ORIGINATION FORM

Proposed Revisions to a Standard Plans Index

Index Number: 700-120
Sheet Number (s): All
Index Title: Enhanced Highway Signing Assemblies

SPREAD FOOTING FOUNDATION

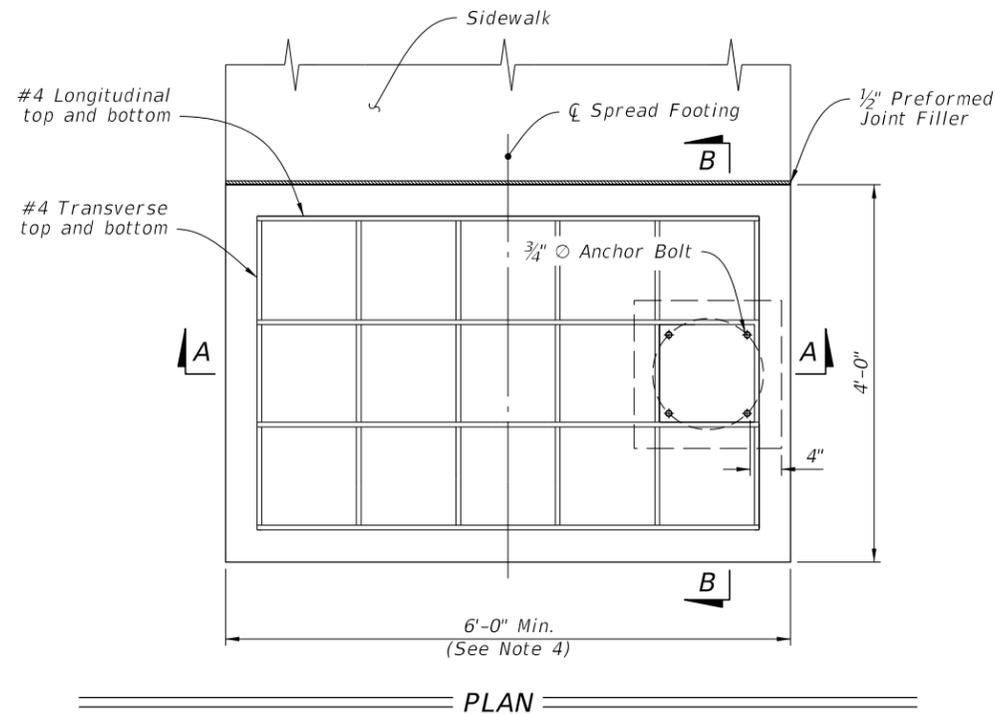
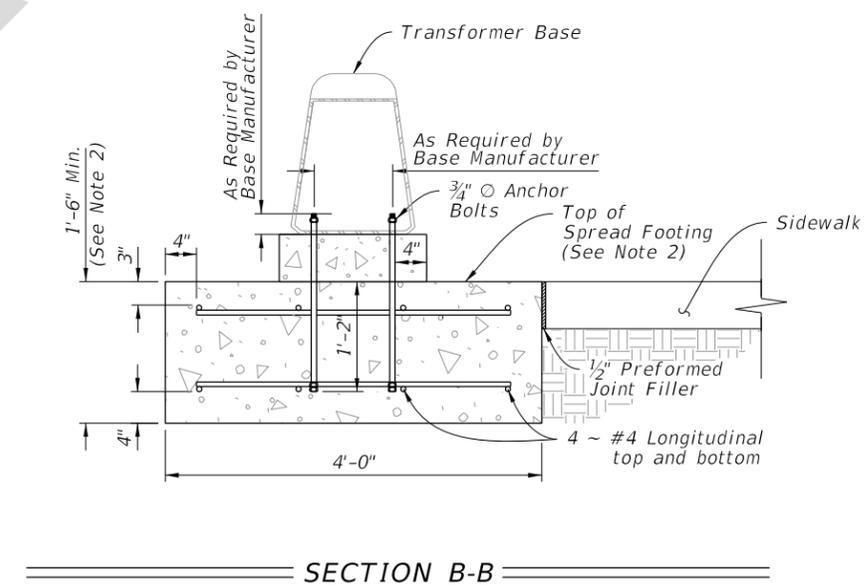
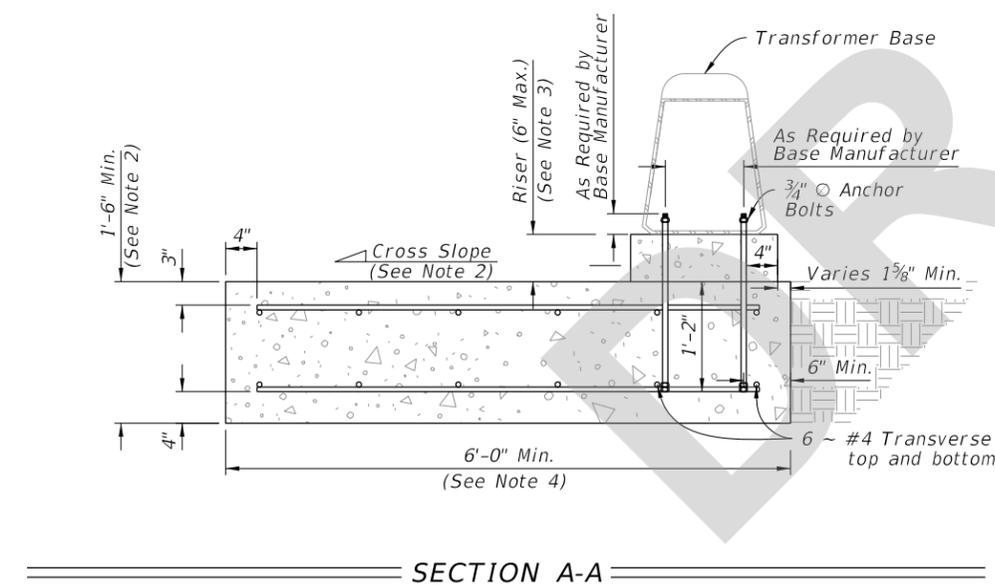
All Sheets: Renumber
Sheet 1: Added New Sheets to Table of Contents.
Sheet 3: New Sheet - Spread Footing Foundation.
Sheet 12: New Sheet - Roadside Sign Assembly-9.
Sheet 13: New Sheet - Roadside Sign Assembly-10.
Sheet 14: New Sheet - Roadside Sign Assembly-11.

The districts have requested a spread footing foundation option be added.

1. Install the Spread Footing Foundation only where called for in the Plans.
2. SIDEWALK:
 - a. When abutting sidewalk, match the cross slope of the adjacent sidewalk or curb ramp where applicable. Maintain the minimum depth of footing.

- b. 1/2" expansion preformed joint filler required between sidewalk and spread footing.
 - c. Apply concrete surface finish to the top of the spread footing in accordance with Specification 522-7.

- d. Sidewalk placed on the other side or both sides of the spread footing is permitted where shown in the Plans.
3. Only use concrete riser when installed in-line with sidewalk curb that results in a drop off to the adjacent sidewalk.

4. For sidewalks greater than 6', match sidewalk width. Add one #4 transverse bar, top and bottom, per additional foot of spread footing to maintain at minimum the same reinforcement area per foot.

5. Base location can vary on spread footing. Location shown in Plans.

ROADSIDE SIGN ASSEMBLY-9

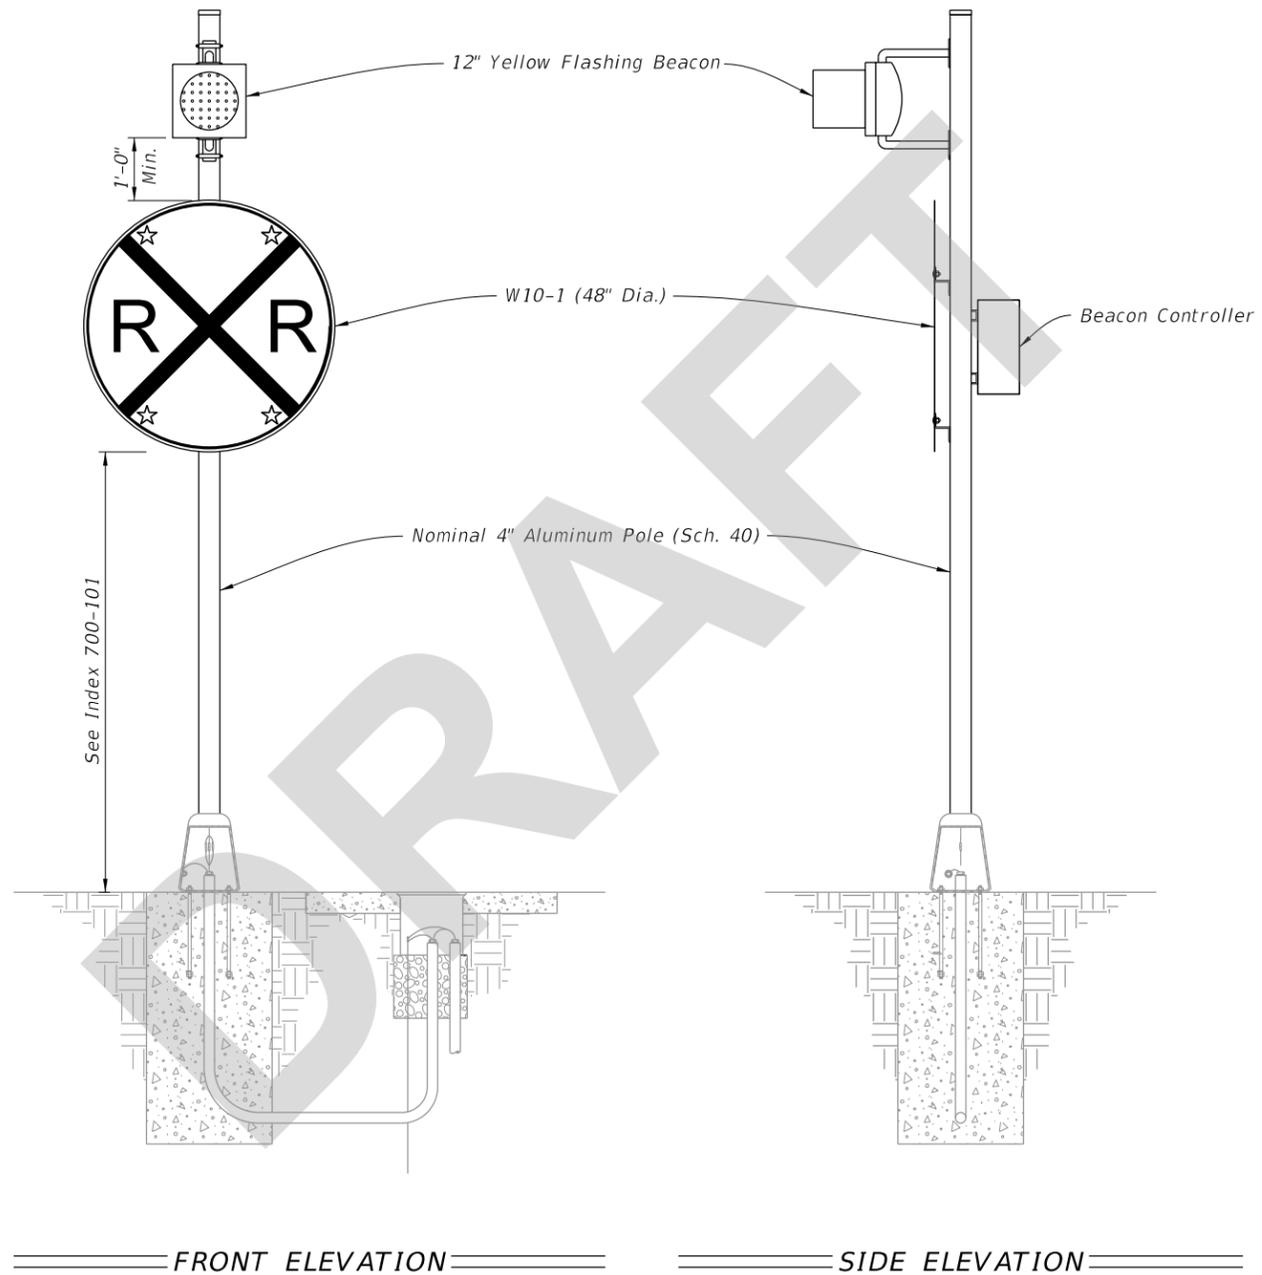
Three new Railroad Highlighted sign assemblies are being added as a result of input from the Rail Safety Task Team.

- 1. Type A9 Assembly (conventionally powered) is shown.
Type B9 Assemblies (solar powered) similar.
- 2. Foundation reinforcement not shown.
